MITIGATION PLAN

ALEXANDER FARM MITIGATION SITE

SUBJECT: Alexander Farm Mitigation Site - NCIRT Comments during 30-day Mitigation Plan Review

RE: Alexander Farm Mitigation Site
Response to NCIRT Mitigation Plan Review Comments
USACE Action ID No. SAW-2018-00451

Figure 9 Concept Design Map
 Alexander Farm Mitigation Site
 Catawba River Basin (03050101)
 Alexander County, NC

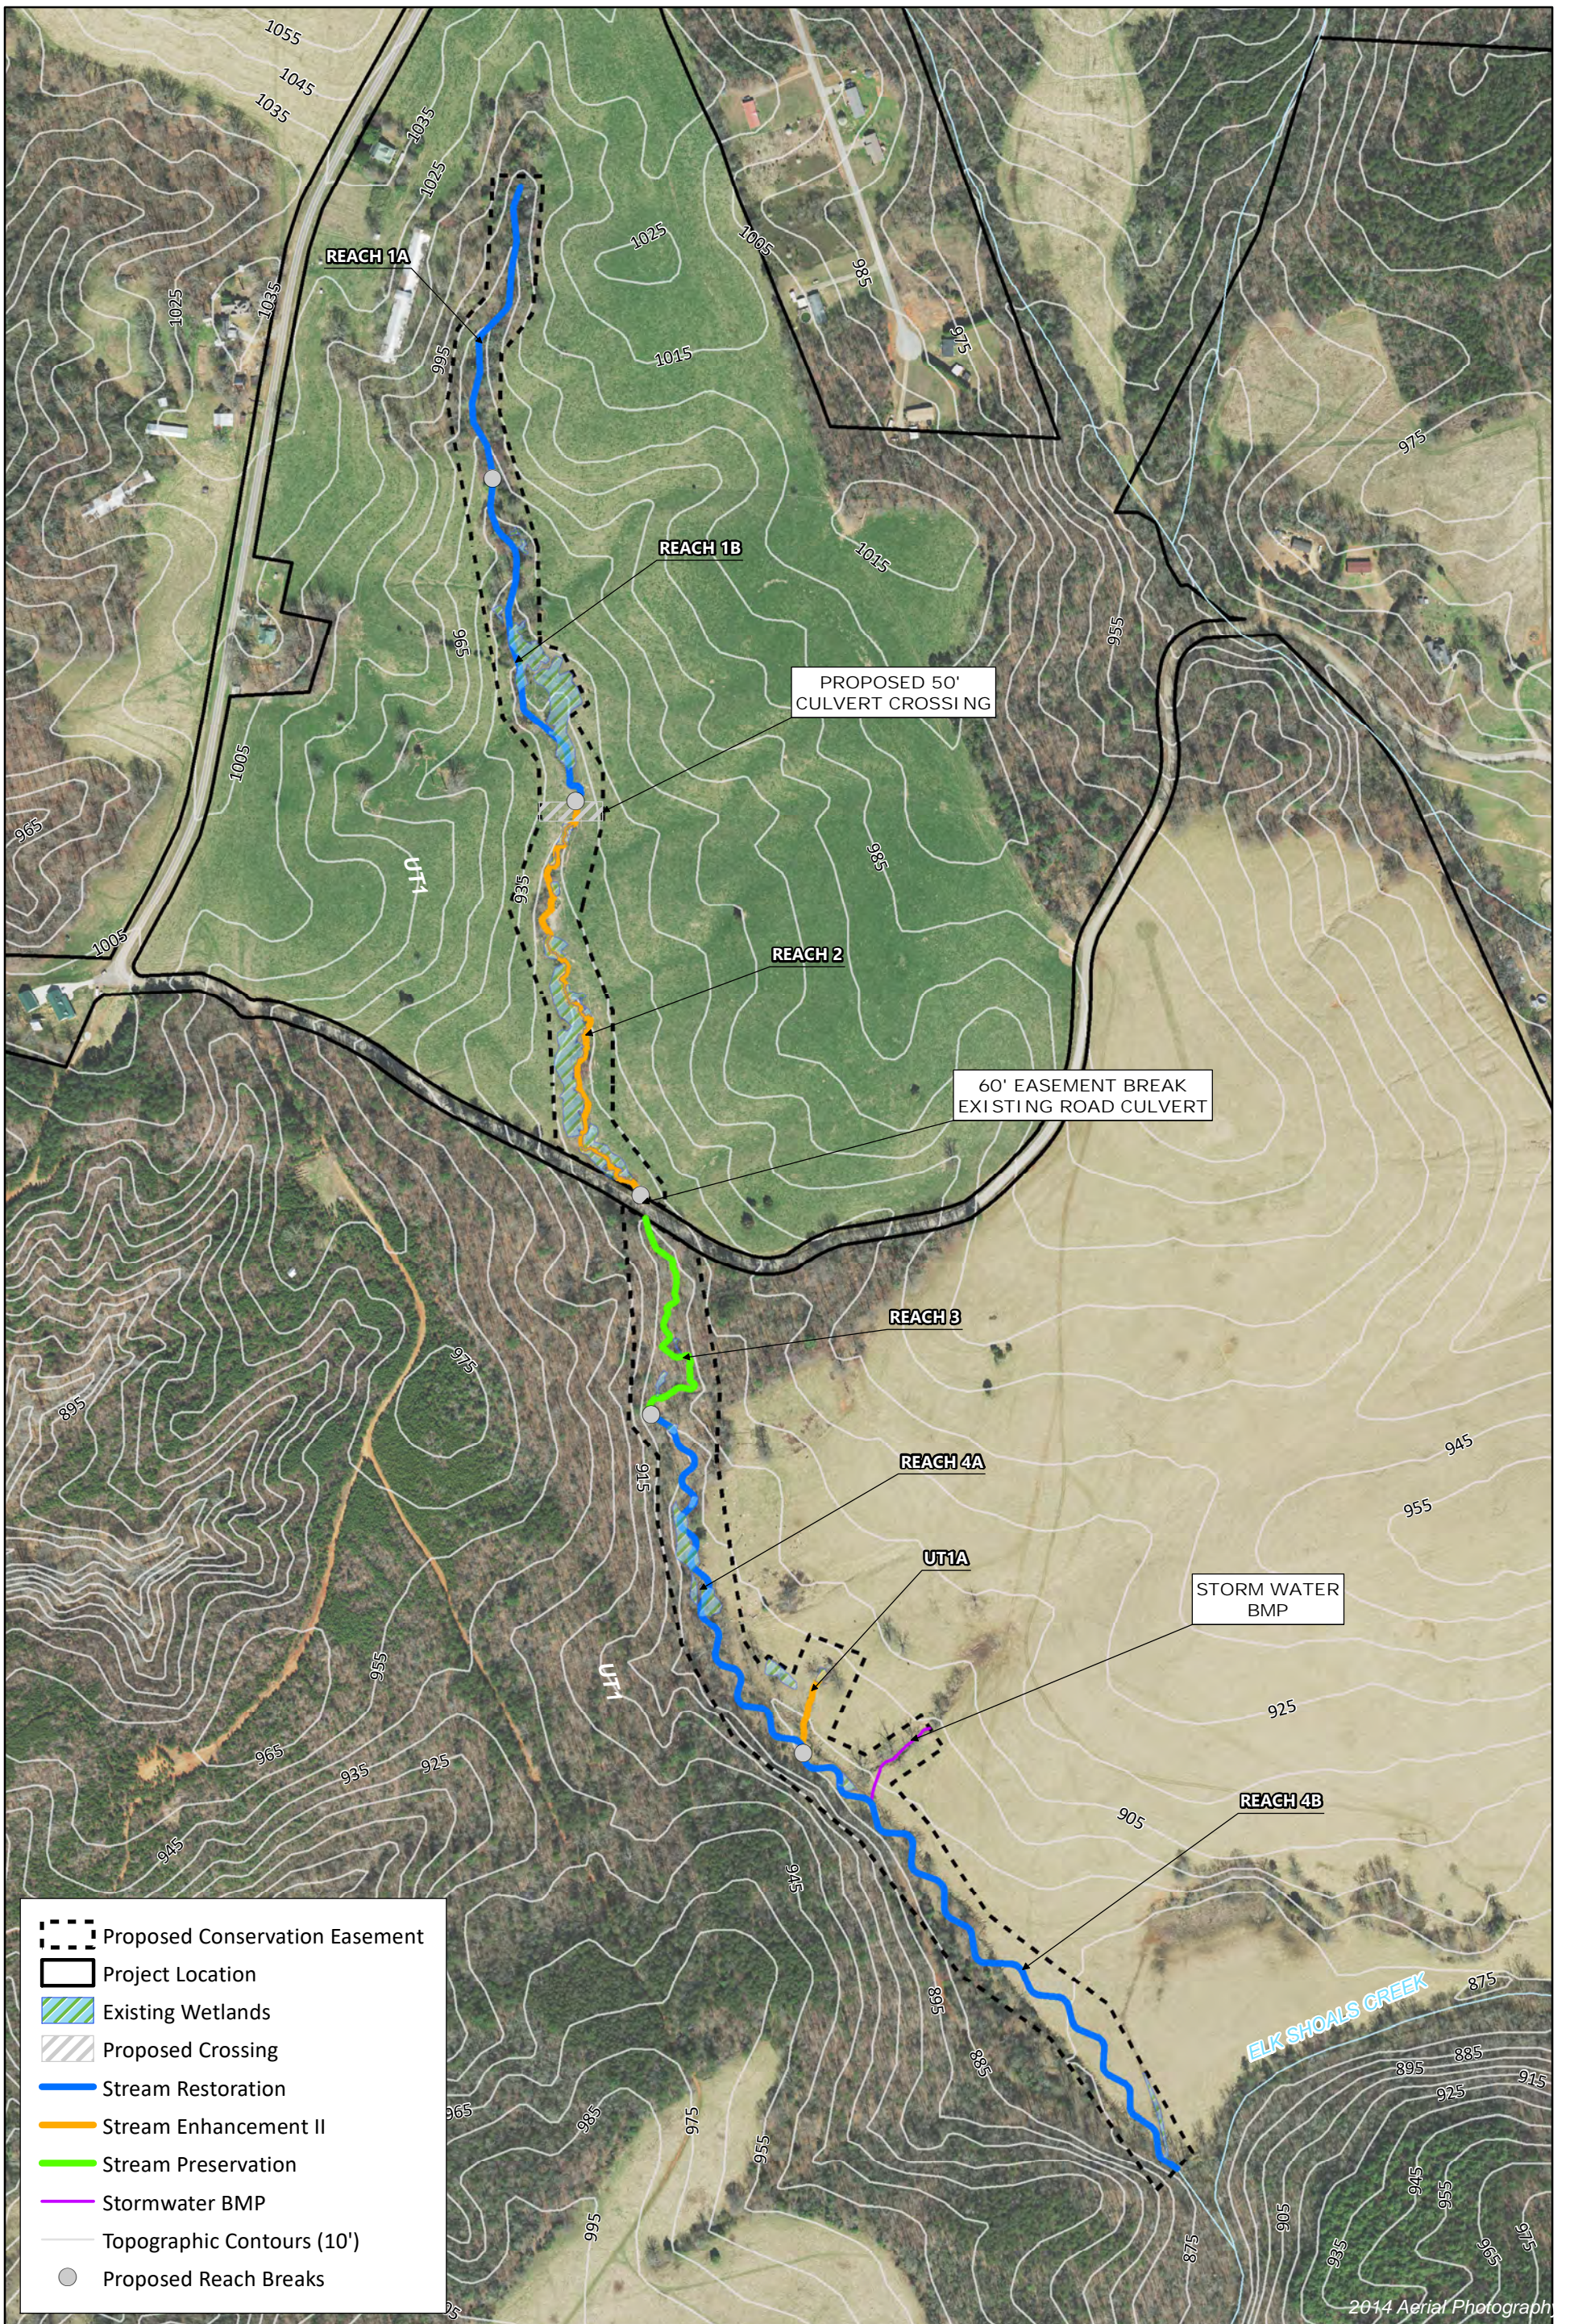
stream channel through Priority 1 restoration? Additionally, there appear to be several more wetlands shown on the JD Map that are not captured on Figure 9.

3. *Section 5.3 and Table 7: There are several reaches of stream restoration proposed (1B, 4A, 4B) that will impact existing wetlands. Please describe how you will ensure that no functional loss/loss of waters occurs. Specifically, will the 0.17 acres of permanent impacts be recuperated adjacent to the newly raised stream channel through Priority 1 restoration? Additionally, there appear to be several more wetlands shown on the JD Map that are not captured on Figure 9.*

Wildlands Response: The existing wetlands that will be impacted by stream restoration activities are currently impacted by cattle grazing and trampling. Priority 1 restoration will allow for the stream to be raised, which will raise the water table helping to restore or enhance the adjacent wetlands. Wildlands will take precautionary measures to protect the existing wetlands, including the installation of safety fence to establish grading limits adjacent to the wetlands. Wildlands will use the project's proposed stream flow pressure transducers or crest gauge to show that stream flooding is enhancing surface hydrology on the floodplain adjacent to project reaches. Figure 10 shows all the delineated wetlands that are shown on the JD Figure. The symbology was changed to make it more visible on the figure. A symbol for large woody debris was added to the plans and placed within the proposed vernal pools.

2.1.5

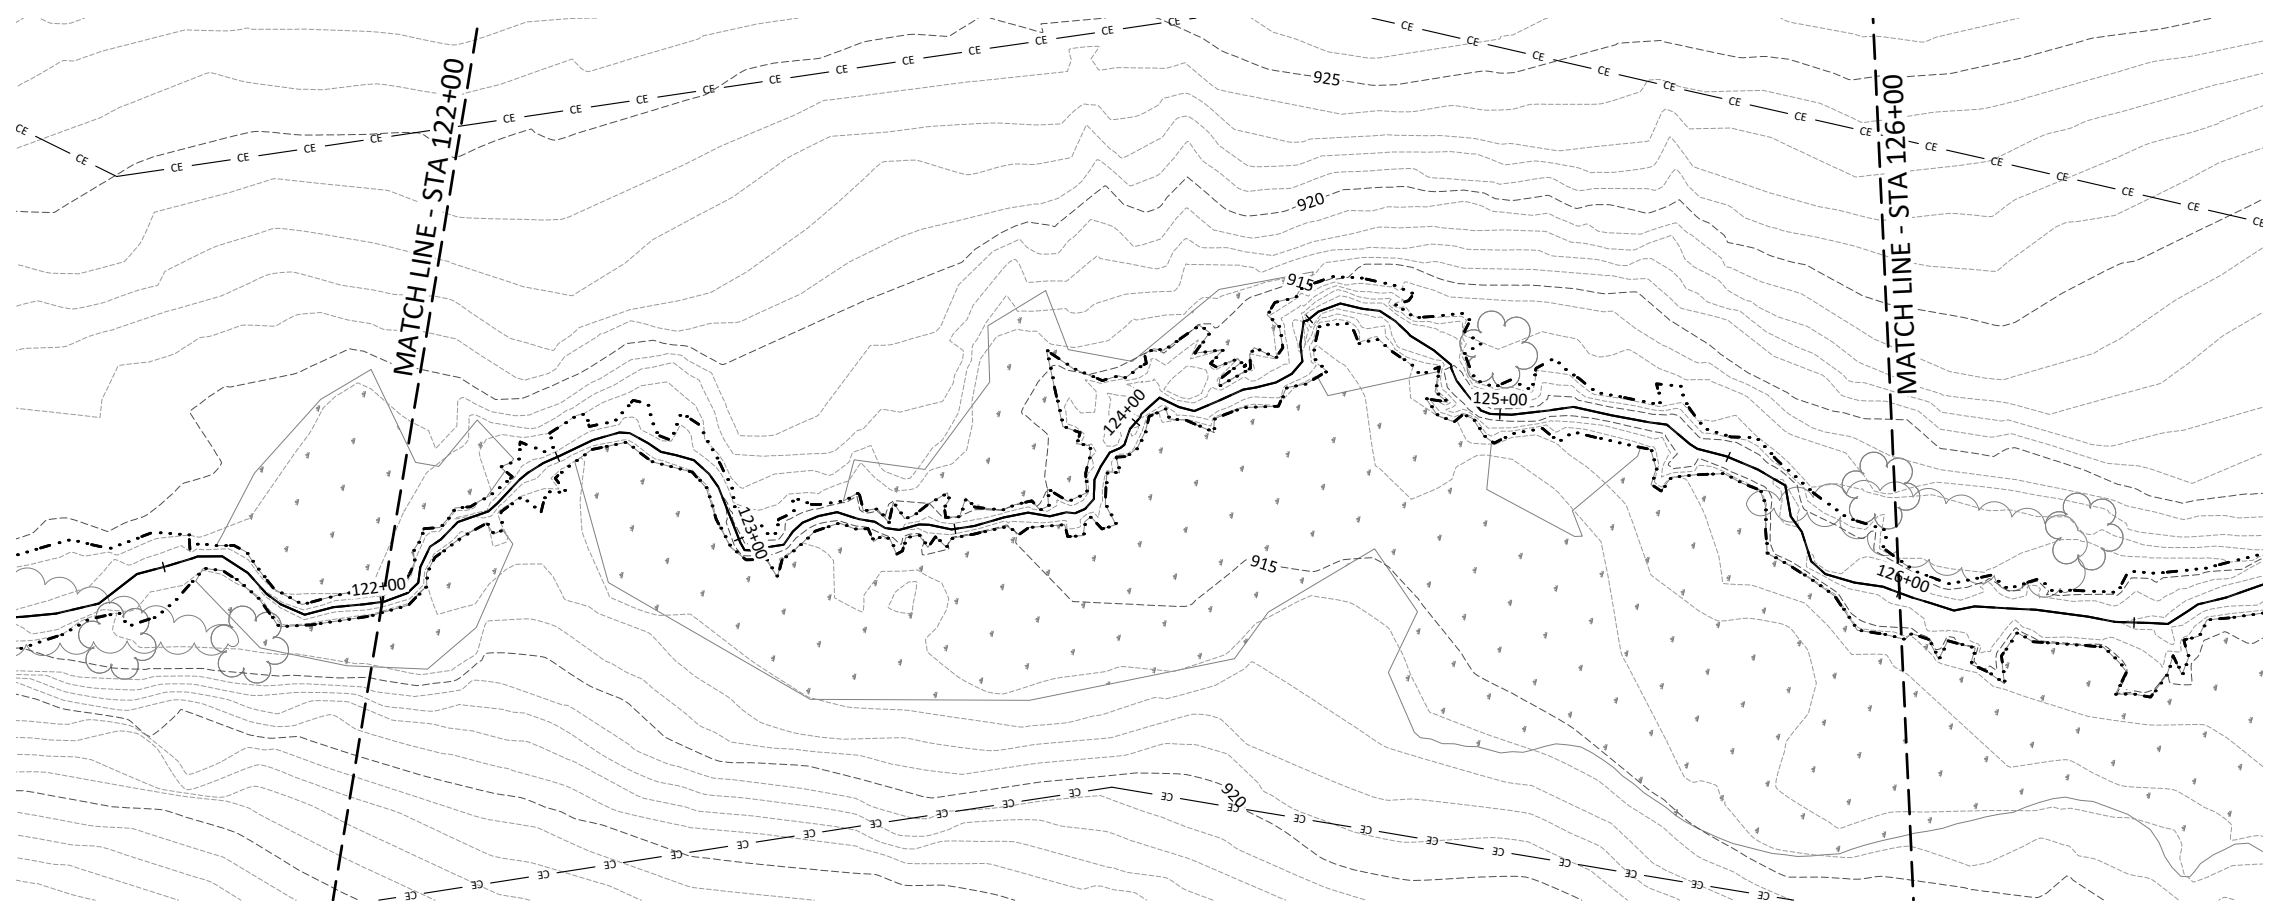
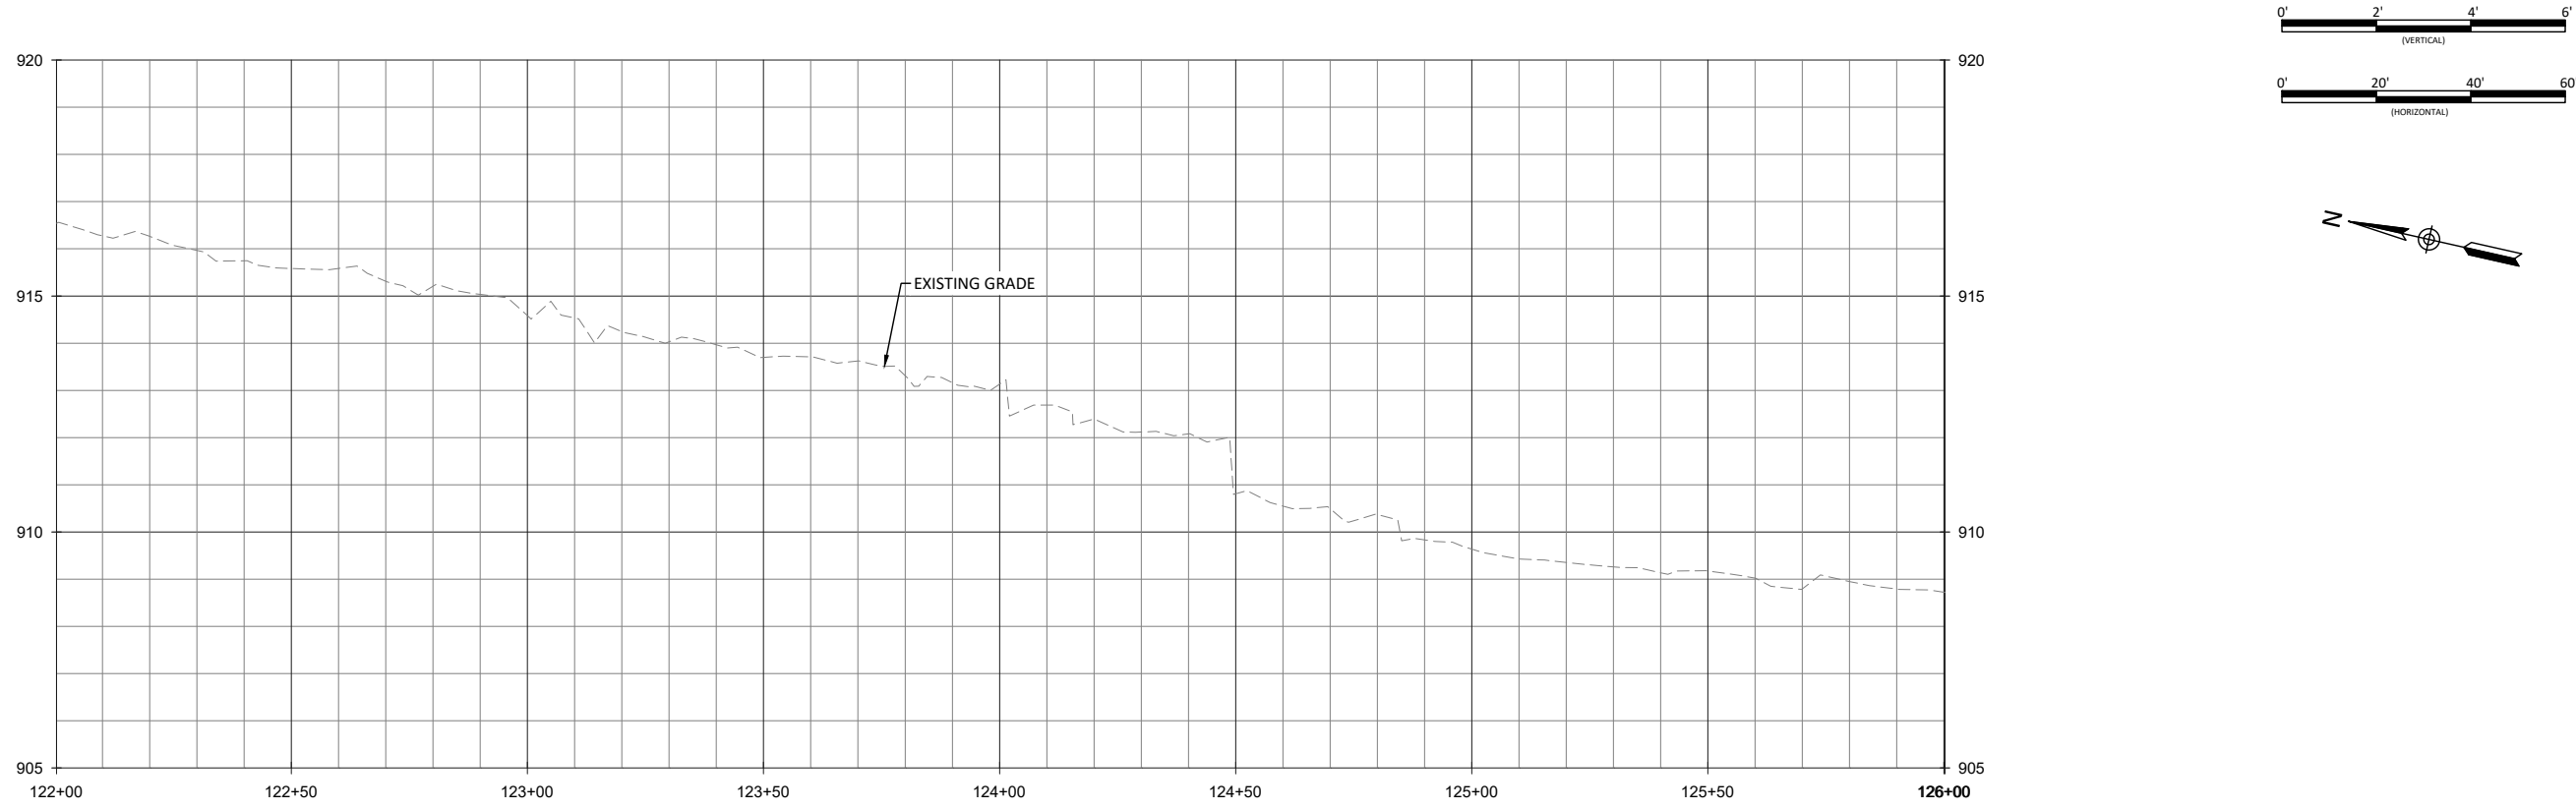
3. *In addition, there are two areas where the designed stream is being built through wetlands and DWR requires a wetland gauge at the following locations:*
 - a. *Design sheet 2.1.4 – station 116+00 stream right, and*
 - b. *Design sheet 2.1.0 – station 142+25 stream right*

Wildlands Response: A wetland gauges were added to the monitoring plan in these locations. We do want to point out that since no wetland credits are being sought, no pre-construction data was collected for any wetlands. There will be no way to compare impact or uplift of these wetlands.
